T270/T370 Treadle Valve Loose Compression Fittings

Title	Recall 19KWD
Search Words	
Bulletin No.	19KWD
What's New Abstract	Safety Recall – Remedy Available. Certain compression fittings on the brake treadle valve may not have received appropriate torque. As a result, a brake application air supply hose may separate from the brake treadle valve, which may diminish vehicle braking capability and may increase the risk of a crash and injury without warning..
Supplier	Dynacraft
Description	Recall 19KWD: T270/T370 Treadle Valve Loose Compression Fittings
Release Date	
Introduction	Kenworth Truck Company has determined that a defect, which relates to motor vehicle safety, exists in certain T270 and T370 chassis manufactured between July 19, 2019 and August 1, 2019.
Situation	144 chassis (139 U.S. and 5 Canada) T270 and T370 built from 07/19/2019 through 08/01/2019 equipped with air brakes.
Resolution	<p>Service all chassis affected that enter your dealership, even if the customer has no issue with the chassis.</p> <ol style="list-style-type: none"> 1. Review the attached chassis list for your dealer code and schedule your customer(s) for service if their chassis is on the list. 2. If you

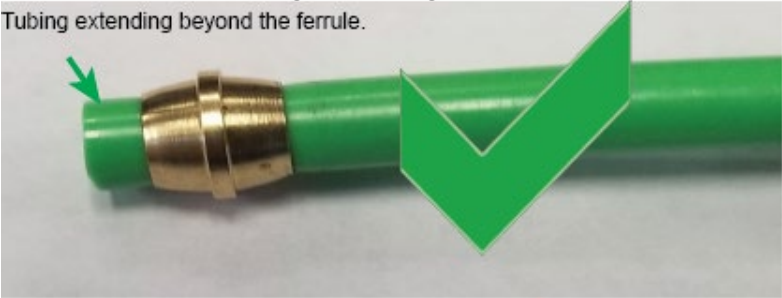
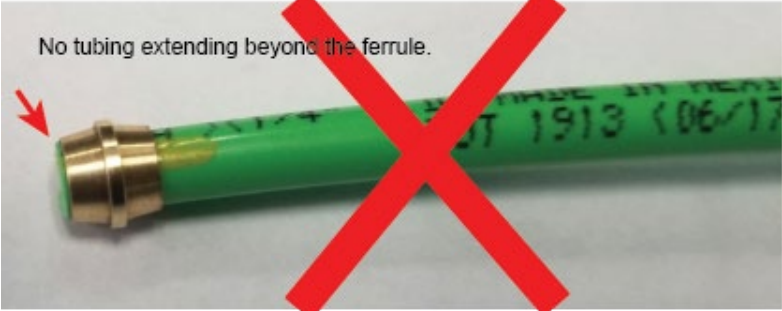
1. Inspect the tubing at Ports 13 and 23 of the treadle valve.
 - If the tubing slides in and out of the compression fitting, push the tubing in all the way and torque the compression fitting nut to 35 lb-ft. (47.5 N·m).
 - If the tubing does not slide in and out of the fitting, continue with this procedure.

Some chassis may have a 90° fitting instead of a straight fitting as shown in the figure below.

2. Remove the compression nut from the treadle valve.
3. Confirm that the ferrule meets one of the following conditions. If it does not, the tubing and ferrule must be replaced. When replacing the tubing, follow the original routing and tubing retention/clipping.
 - Condition 1: Slides easily on the tubing

<ul style="list-style-type: none"> Condition 2: Has tubing extending out of the end of it. Tubing extending beyond the ferrule.   <ol style="list-style-type: none"> Align the tubing and ferrule with the appropriate treadle valve port, start the compression nut, push the tubing into the port while tightening the compression nut to 35 lb-ft. (47.5 N·m).
Shipping	
Freight	
Contact	
Attachments	Dealer\Chassis List
